RE: ERA17FA190

We appreciate the opportunity to respond to the draft factual report. Please accept the attached as Metro Aviation's submission on ERA17FA190.

Addendum for ERA17FA190

Figure 5 - Radar flight track of the final segment of the accident flight of N62UP. This is a side view of the final segment, with the ILS glideslope depicted in order to illustrate the descent profile of N62UP while on final approach.

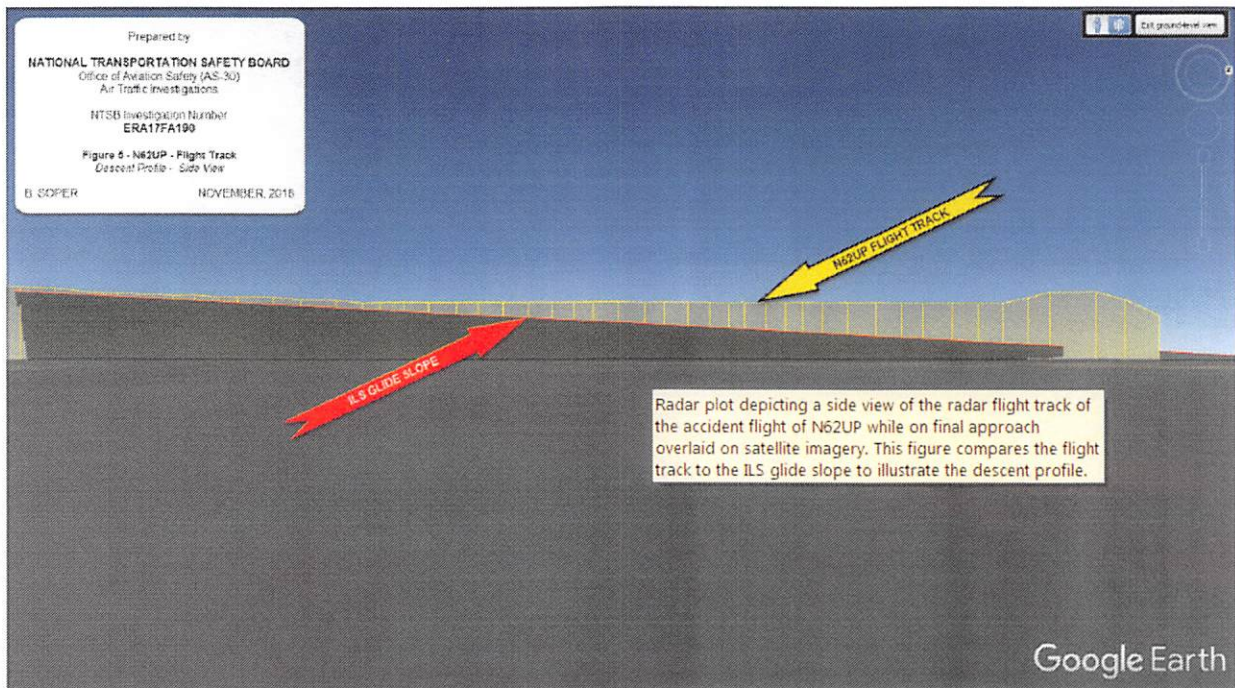
Both the PHL and ILG ATC facilities failed to notice or react to N62UP not descending on glide slope after passing the final approach fix on course. Controllers at both facilities stated they would ordinarily provide advisories to both course and azimuth to aircraft inside the final approach fix.

Prior to this read back instruction, all of the read back from N62UP had been correct. The transcript for the SD indicates the SD used the words “to established” not “until established” and the read back from N62UP did not include either phrasing or terminology. (Report line items 201 through 207) N62UP did not descend after crossing the FAF and intercepting the localizer.
